**RE: FLOOD EROSION PROTECTION – PRAIRIE CREEK MINE, NT**

**Board Approval: Bulk Fuel Storage Facilities Condition Inspection Report**

<b>Company:</b> Canadian Zinc Corporation (CZN)	
<b>Location:</b> Prairie Creek Mine	<b>Application:</b> MV2001L2-0003
<b>Date Prepared:</b> December 29, 2005	<b>Meeting Date:</b> January 11, 2006
<b>Subject:</b> Report approval – Condition Inspection Report for the Bulk Fuel Storage Facilities

<b>Company:</b> Canadian Zinc Corporation (CZN)	
<b>Location:</b> Prairie Creek Mine	<b>Application:</b> MV2001L2-0003
<b>Date Prepared:</b> April 4, 2005	<b>Meeting Date:</b> April 12, 2005
<b>Subject:</b> Plan approval – Prairie Creek Geotechnical Site Reconnaissance Report (Flood Protection Work and Tank Farm Facility)

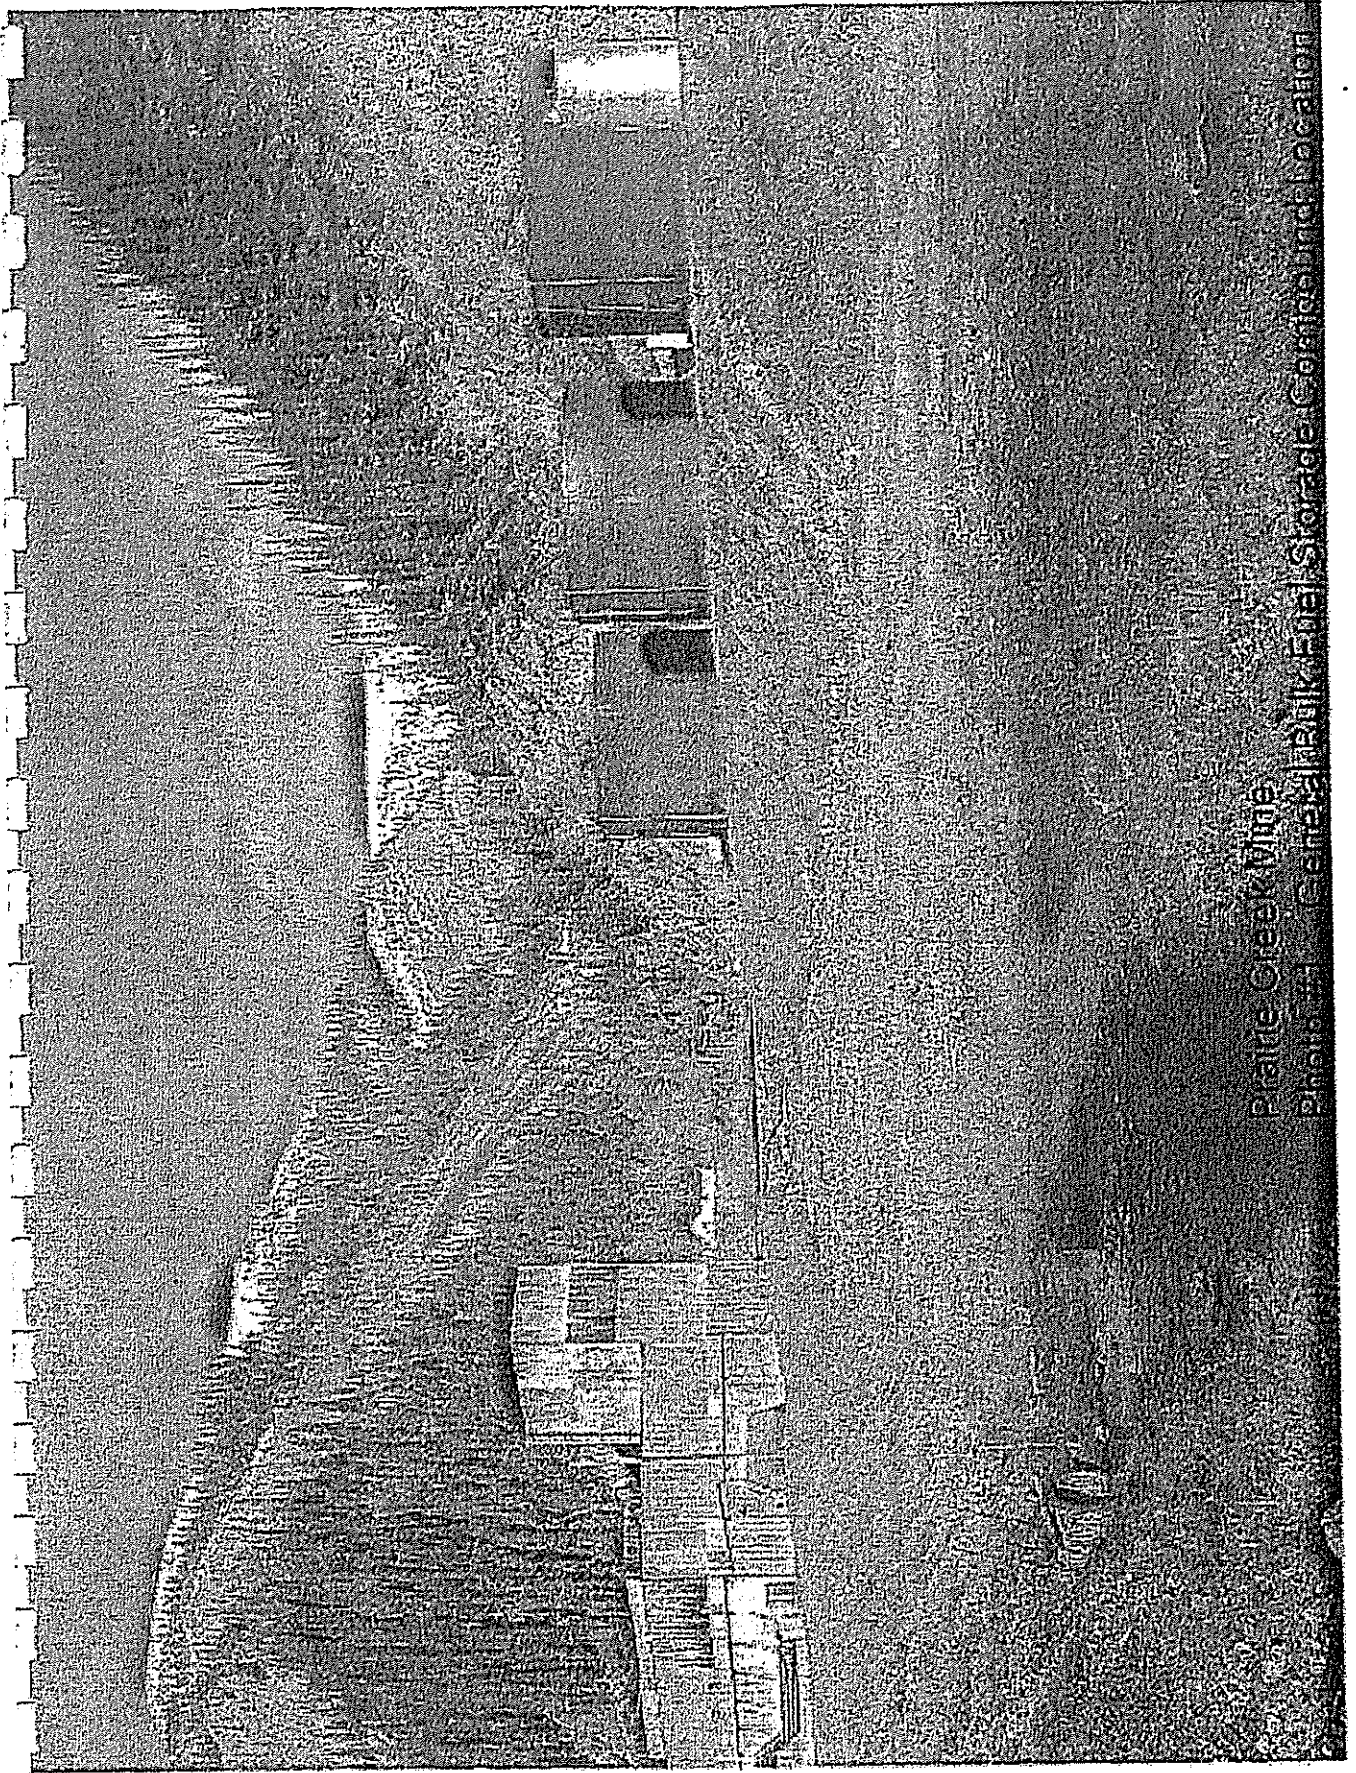
\*7 Tank is equipped with a gooseneck vent, which acts as a painters post.  
 \*8 42" high x 7' long angle iron handrails at roof equipment.  
 \*9 The gauge head and marker is dislodged from the board and needs to be repaired.

Note: With the above corrections, Tank #4 is hereby certified for continued diesel fuel service, with regular maintenance and inspection.  
 A full Out-of-Service API 653 tank inspection of Tank #4 will be required before the mine is put into operation.

**Figure 1: Flood Protection Works at the Prairie Creek Mine Site**

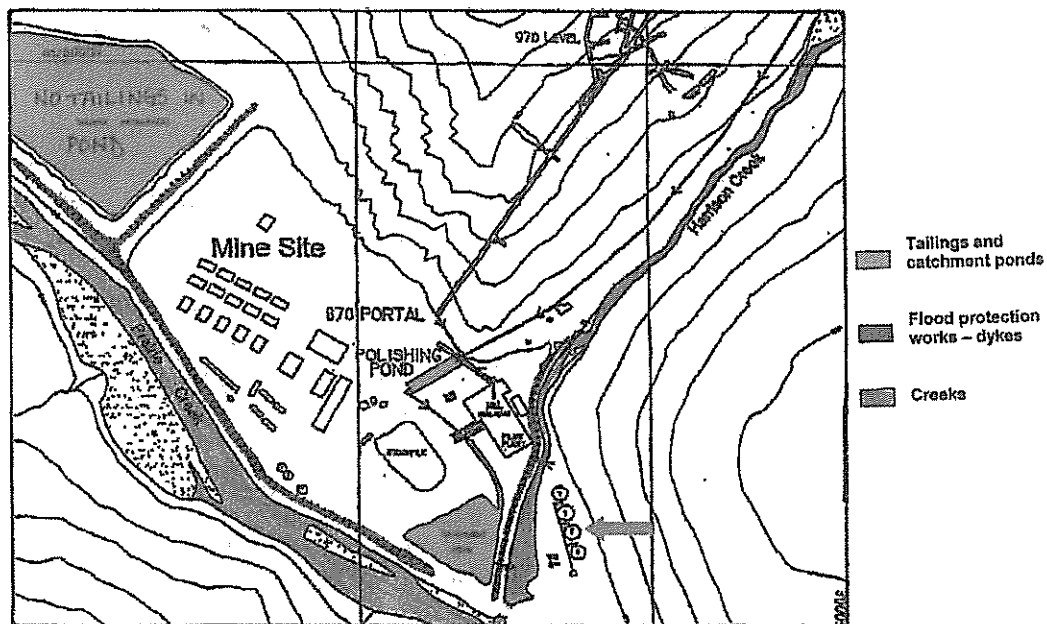
The geotechnical evaluation of the Flood Protection Work at the Prairie Creek Mine site as shown in green in Figure 1 below was conducted by EBA Engineering Consultants Inc. (EBA). The standard that EBA considered most appropriate for assessing the Flood Protection Work was the 200 year flood estimate presented in the *Probable Maximum Flood Profile Report (PMFPR)* that the Board approved at the March 23, 2005, Board meeting.

**Photo 4**  
Riprap Berm Along Prairie Creek Below Tailings Pond

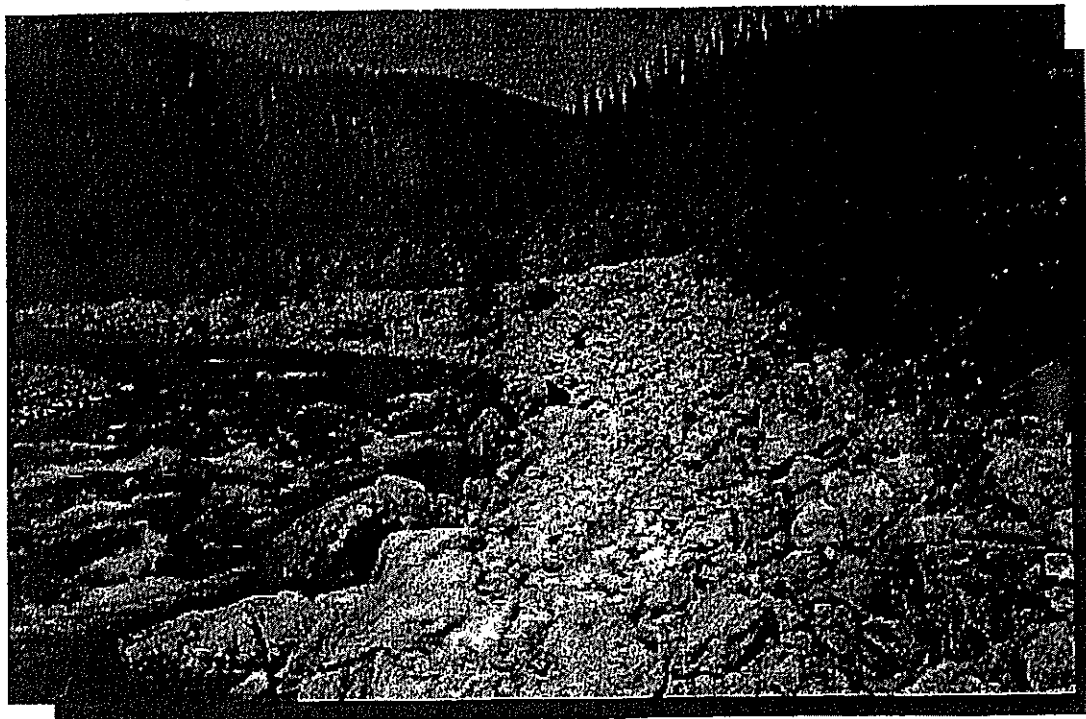
The entire length of the riprap berm was examined on foot during the site visit. Photos 4 to 6 show the location and condition of the riprap. The twigs in Photo 5 probably represent the maximum elevation of high flood during the service life of the dyke. The following observations were made during inspection.

- There is no indication that the riprap, installed in 1981, has ever been overtopped.
- The rock size varies from about 100 mm to greater than 1,000 mm, with an estimated median size of 200 to 250 mm.
- Larger boulders have been added at the bend in the channel where the dyke is most susceptible to erosion.
- The gravel slopes supporting the riprap (2H to 1V) are stable with no evidence of sloughing or cracking.
- There is one short section near the bend where the surface riprap seems thinner on the upper slope, suggesting some localized surface movement.
- There is no indication of sediment loss from the riprap slope to the stream.
- There is a short section of dyke downstream from the tailings embankment where it appears the riprap was not completed during the construction period. That section is not in a zone subject to high water velocities.

Considering that there are no significant environmental consequences should a portion of the dyke erode, it is a realistic approach to risk management to conclude that the dyke and riprap are fully serviceable in their current condition for current exploration operations. This conclusion will need to be re-examined when a plan for future use of the pond, originally designated for tailings disposal, is presented for Water Board consideration, or when a full site reclamation and abandonment plan is developed. At that time, the failure consequences will change and the requirement for long-term stability of the riprap will require a more detailed re-evaluation.
